**SECTION 75W REQUEST TO MODIFY THE MINISTER'S APPROVAL OF  
PROJECT APPLICATION 06\_0250 (28 JUNE 2010) – NELSON BAY ROAD,  
FERN BAY.**

**MODIFICATION 9 - DESIGN CHANGES TO STAGE 14 AND THE ACCESS  
INTERSECTION WITH NELSON BAY ROAD AND CHANGES TO  
APPROVED SUBDIVISION LAYOUT OF STAGES 18 – 20 INCLUDING  
UPDATED SUBDIVISION PATTERN AND RELOCATION OF PROPOSED  
PUMP STATION P3.**

Figure 1: Aerial Photograph of Seaside Village Development with modification locations indicated

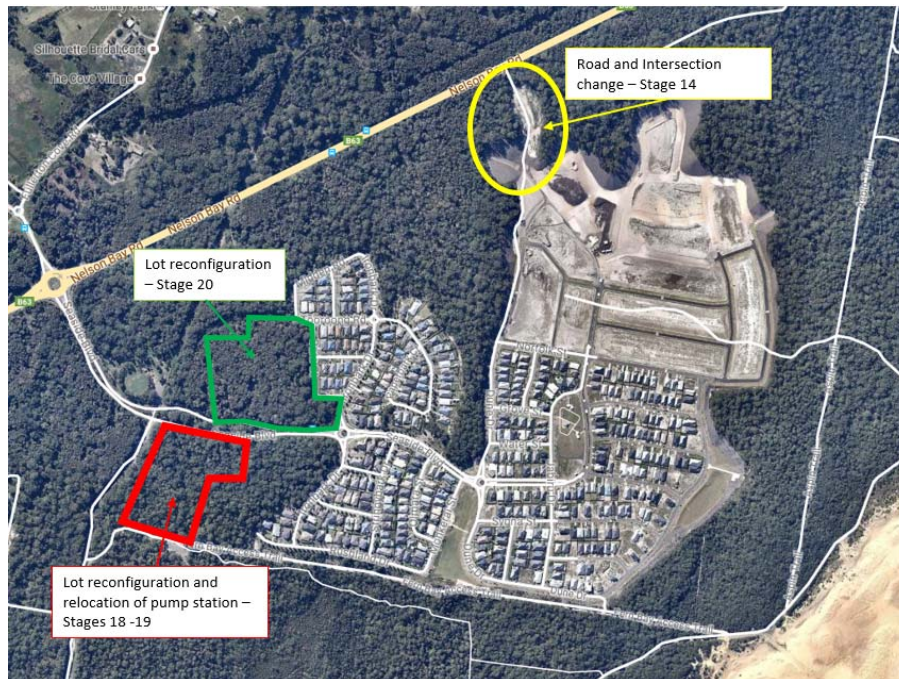
1. Modified road layout amending the approved connection from Seaside Boulevard to Nelson Bay Road for Stage 14 to an 'Emergency Access ONLY Track'. The northern end of Seaside Boulevard before the start of the 'Emergency Access ONLY Track' is to terminate in a turning circle and consequently, deletion of condition B5;

2. Reconfiguration of lot layout to Stages 18 and 19 resulting in 51 lots due to the proposed subdivision of approved super lots into standard sized lots for dwelling houses. This reconfiguration includes 43 residential lots and 8 commercial lots as nominated on the plans. The reconfiguration would result in a minor encroachment of the road around this stage into the E2 zone (we note that roads are a permissible use within E2 zone);

3. Reconfiguration of Stage 20 resulting in 34 residential lots due to the proposed subdivision of approved superlots into standard sized lots for dwelling houses;

4. Relocation of Pump Station P3 from the western side of Stage 18 to the eastern side of this Stage (while remaining within the R2 zone and outside of the E2 zone and avoiding existing infrastructure).

Figure 2: Extract from plan numbered 29850L sheet 20 of 21 – Aerial View Rev-L – Project Plan L – dated 01/11/16 prepared by North Point Surveys.

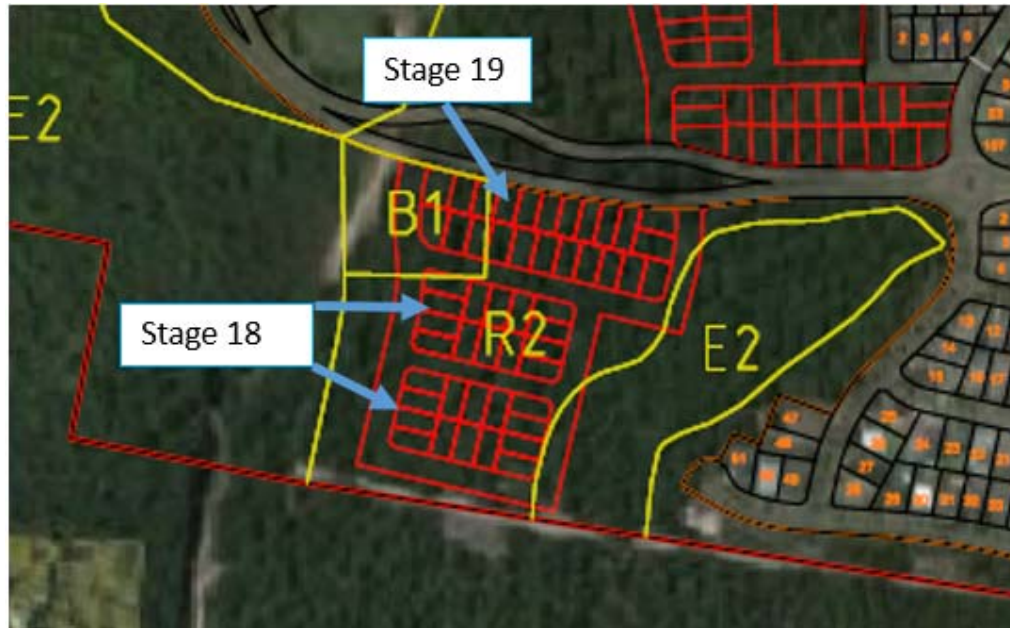
Under the PSLEP 2013 the B1 Neighbourhood Centre zone currently applies to the north western corner of Stage 19 as shown below.

This modification seeks to retain the approved area of B1 Neighbourhood Centre zoning and commercial lot configuration and modify the configuration of the rest of Stage 19 as previously approved. The proposal includes eight (8) commercial lots to this stage relying upon the permissibility of Neighbourhood Shops within the R2 zone in regard to the two 'commercial' lots that are located in the R2 zone being Lots 467 and 474.

Figure 5: Extract from Landscape Plan – Previously approved Mod 8 (left hand side) and proposed (right hand side)

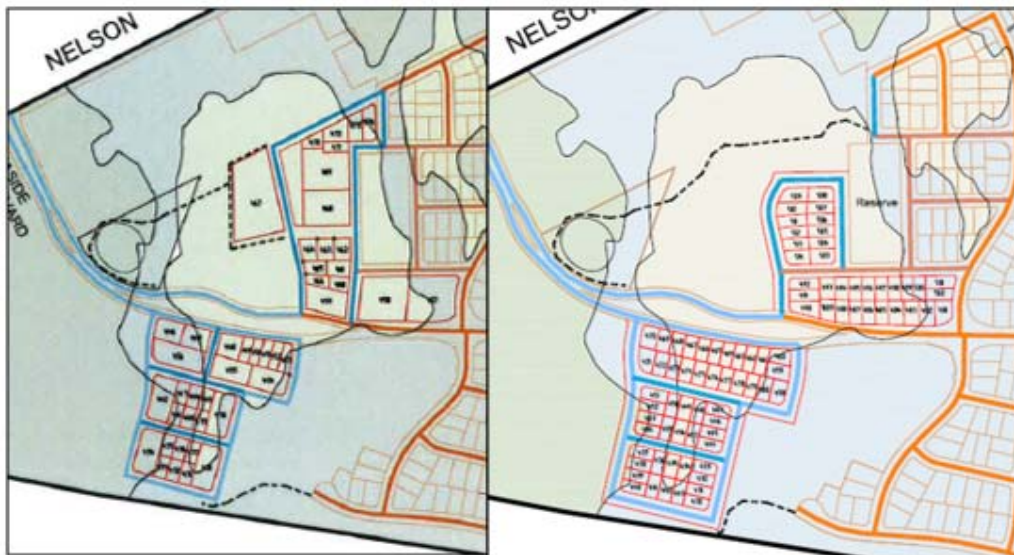
The extracts above illustrate the Lot Size and shape modifications included in this application as compared with the previously approved Modification plans (Mod\_08). As can be seen the number of residential superlots is reduced to zero and the shape of Stage 20 is amended to remove a superlot from the R2 area thereby reducing localised environmental impacts. In particular, the changed shape reduces the area of Swamp Mahogany Paperbark Forest affected by the application. The previously approved modification encroached into this area further. This is shown below, comparing the previously approved Landscape Plan and the proposed landscape plan (for Stages 18-20).

The block amendment shown above produces a far better environmental outcome, achieving a reduction in localised impact upon the surrounding woodland areas. Given the scale of the development as a whole and extensive environmental considerations previously undertaken, it is requested that the modification be given consideration in light of all previous mapping. It is noted that the site is not considered to be of heritage significance and this proposal results in the retention of woodland areas currently intact on the site (site inspection undertaken as part of this reporting process). The redevelopment of this area has been and will continue to be undertaken sympathetically and sensitively as required by existing conditions of consent, ensuring the protection of the surrounding natural environment.
